**MARICOPA COUNTY**  
*Department of Transportation*

**MEMORANDUM**

**Subject:** Revision to Section 405 MONUMENTS and Detail 120

**Case 14-02**

**SURVEY MARKER**

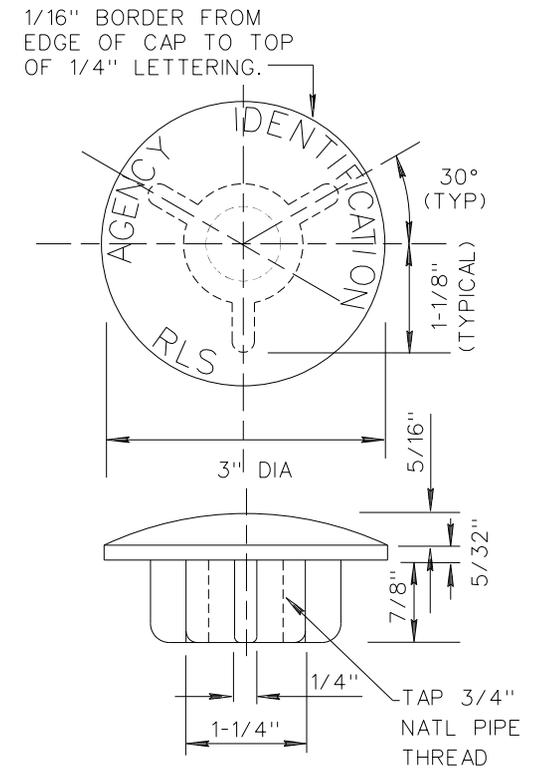
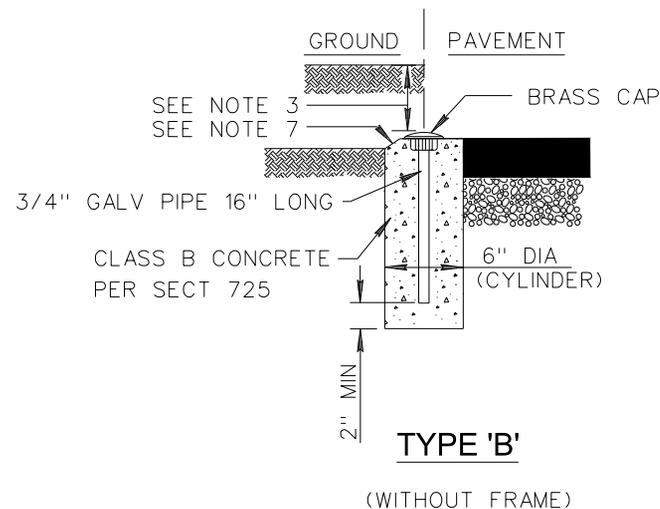
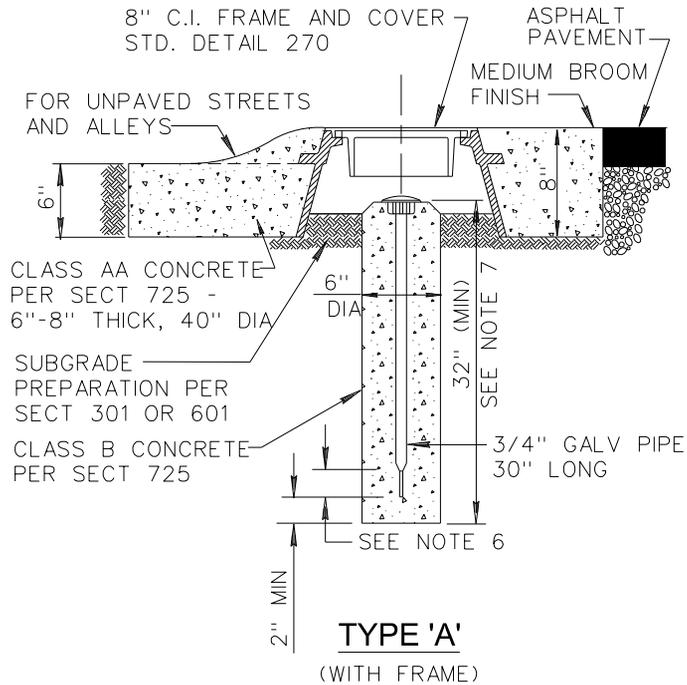
**PURPOSE:** Update specification to match current details and requirements.  
Deleted Type C Monument and modified Type B Monument to have the depth recessed six inches below finished grade when located in an unpaved roadway or alley.

3. FOR UNPAVED STREETS AND ALLEYS SET TOP OF MARKER SIX INCHES BELOW FINISHED GRADE.
4. CAP TO BE CONSTRUCTED OF RED BRASS OR BRONZE.
5. LETTERS TO BE APPROX. 1/32" WIDE & 1/32" DEEP.
